**MECHANICAL
INTEGRITY TEST
(MITs)**

PRESSURE FALLOFF TESTING WORK PLAN

**HOLLY FRONTIER NAVAJO REFINING (NAVAJO)
WDW-3 GAINES
ARTESIA, NEW MEXICO**

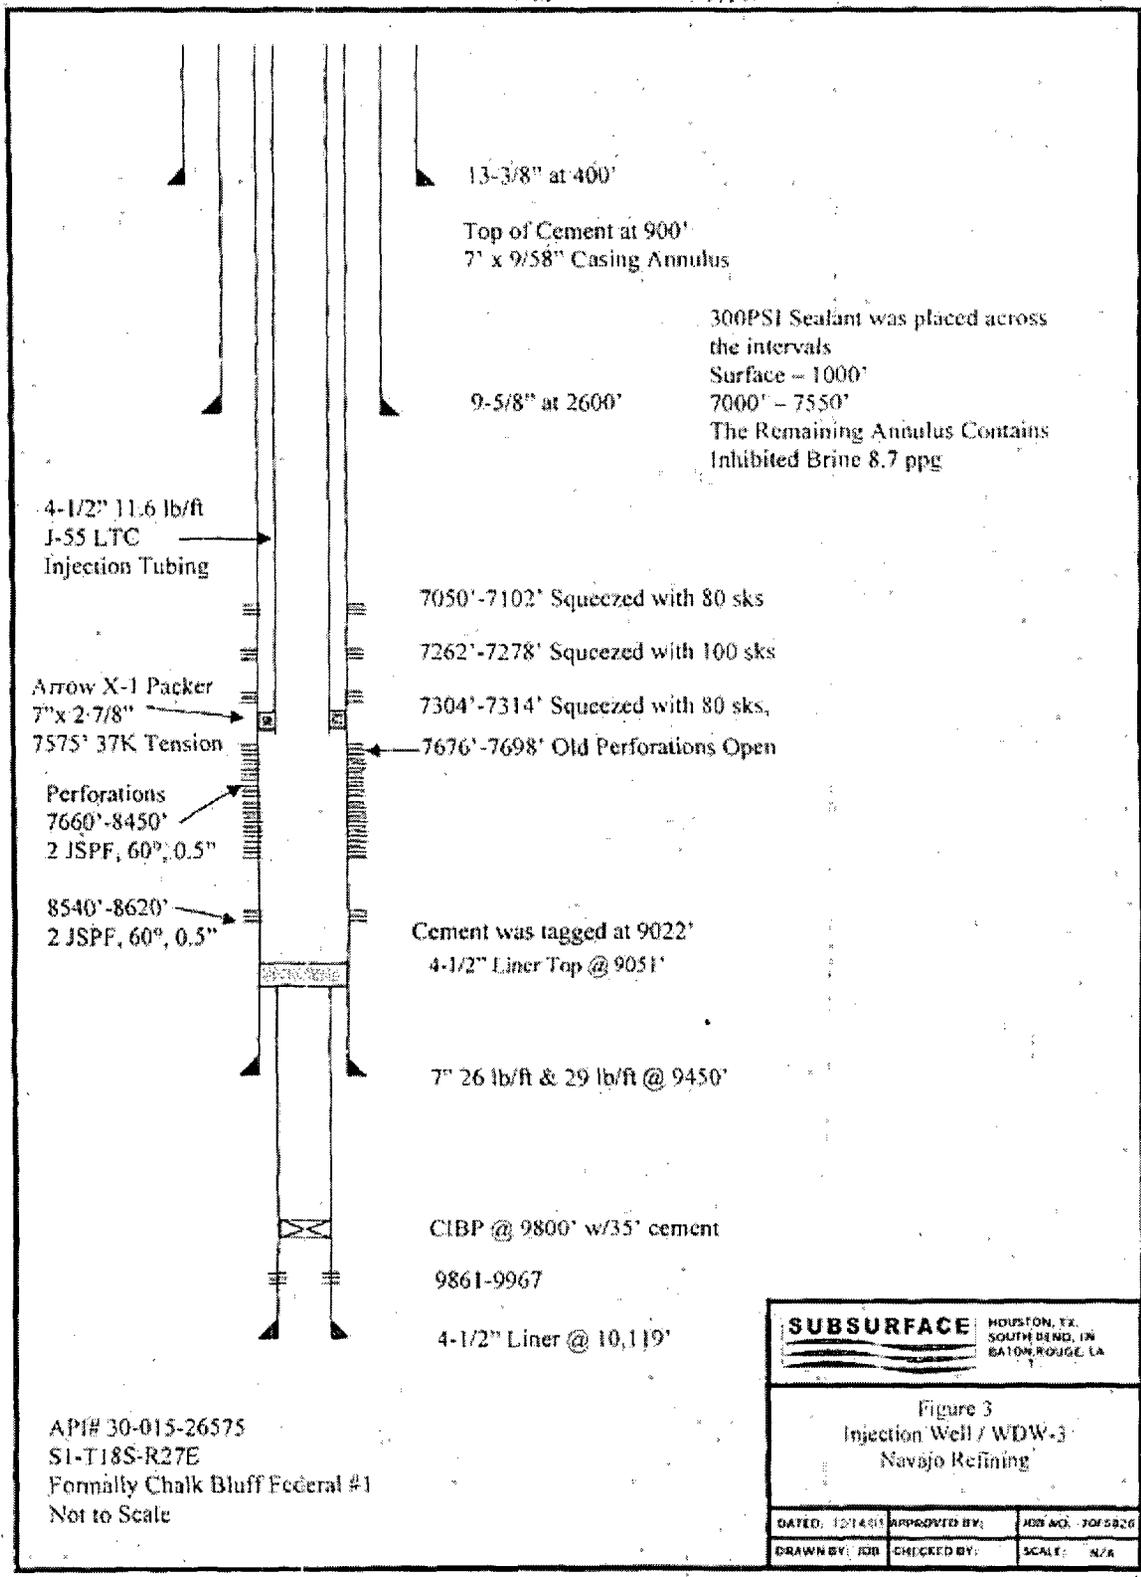
The OCD is aware of the most recent attempt by a company called "300 PSI" (see Well Diagram below with depths of sealant placement within the well) to isolate and repair leakage in the well system using a proprietary sealant. However, it appears that there is still a leak and the OCD notices an increasing pressure loss over the past 2 years of standard annulus pressure tests or MITs of the well, which may indicate the leak size may be increasing? Regardless of the pressure loss, leak rate, and passing of a standard OCD MIT, the leak indicates that there is a well system failure.

In addition, the OCD considered your proposal in the field during the most recent MIT Inspection on Friday, August 14, 2009, which was to replace the fluid and/or augment the existing ethylene glycol with a leak additive standard to ethylene

WAMs Unit near wellhead w/ drums of ethylene glycol not stored in impermeable area

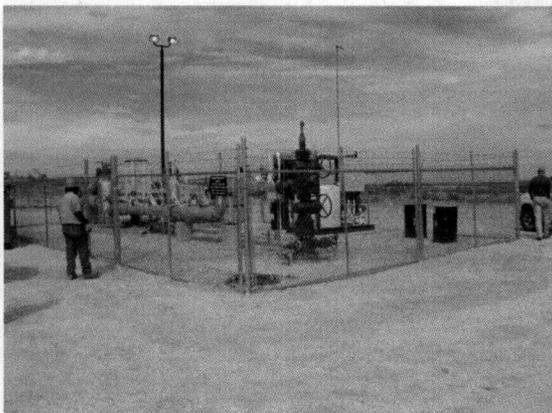
As you indicated in the field, you have placed any drums in the fenced security area into the impermeable pad area. In addition, to indicated that an RFE would be submitted to replace the ½ inch diameter with 1 inch diameter piping due to concerns about high-pressure on a small line and over concerns of breakage of the small line during future MITs, etc.

Rusty fittings near wellhead pinhole leak(s)?

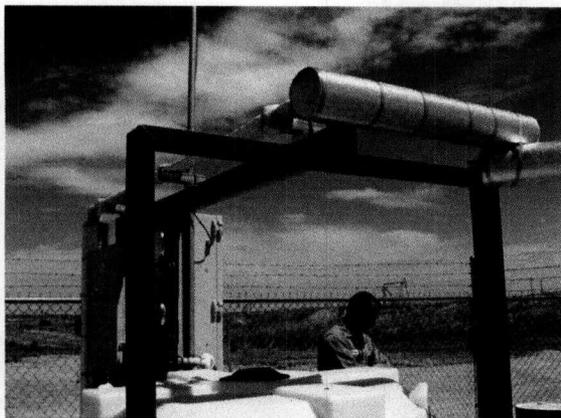
Operator wants to replace $\frac{1}{2}$ inch nipple w/ at least 1 inch over breakage concerns and high pressure on small diameter pipe during the MITs, etc.

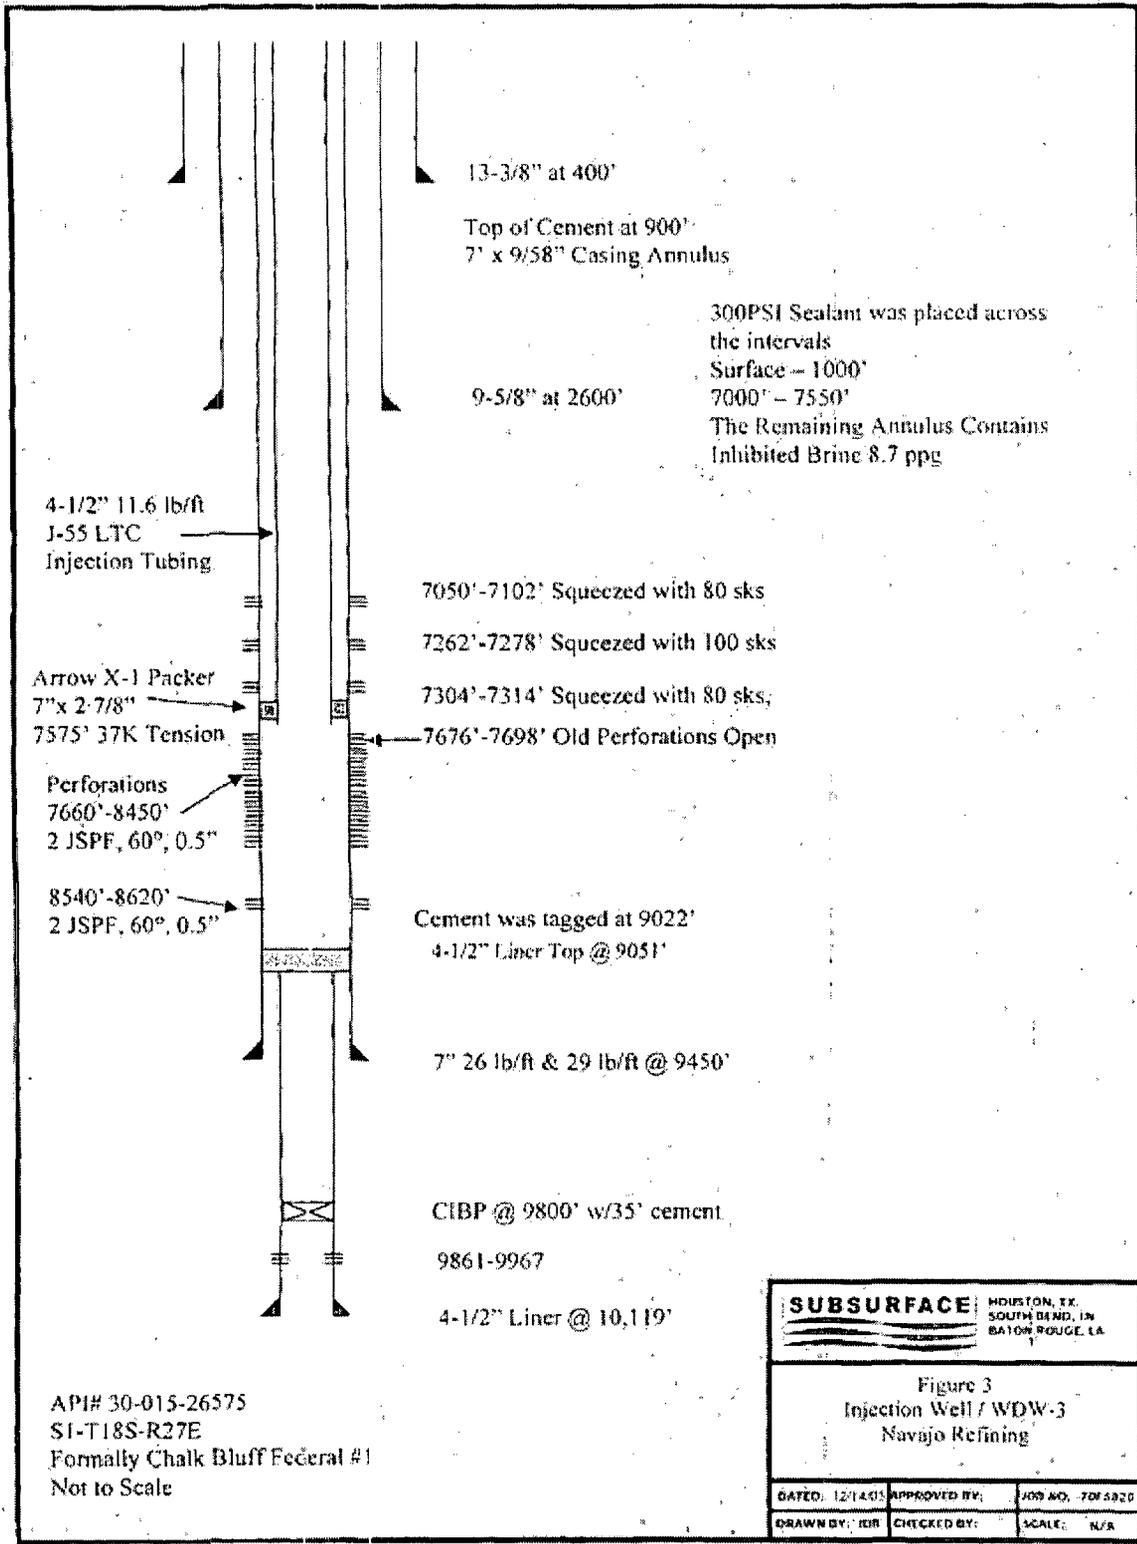
The OCD is aware of the most recent attempt by a company called "300 PSI" (see Well Diagram below with depths of sealant placement within the well) to isolate and repair leakage in the well system using a proprietary sealant. However, it appears that there is still a leak and the OCD notices an increasing pressure loss over the past 2 years of standard annulus pressure tests or MITs of the well, which may indicate the leak size may be increasing? Regardless of the pressure loss, leak rate, and passing of a standard OCD MIT, the leak indicates that there is a well system failure.

In addition, the OCD considered your proposal in the field during the most recent MIT Inspection on Friday, August 14, 2009, which was to replace the fluid and/or augment the existing ethylene glycol with a leak additive standard to ethylene glycol refrigerants to fix the problem. Ethylene Glycol is a listed contaminant under 40 CFR 302.4 with a Reportable Quantity for Releases to the NRC (Ethylene Glycol CAS No. 107-21-1 3 5000 lbs. (2270 kg)). Consequently, the OCD cannot condone the continued use of a hazardous compound under its Underground Injection Control Program in a disposal well that is known to be leaking and in an area underlain by an USDW(s). According to the most recent public notice for this well, fresh ground water (~1500 ppm TDS) is present at about 80 ft. below ground level.
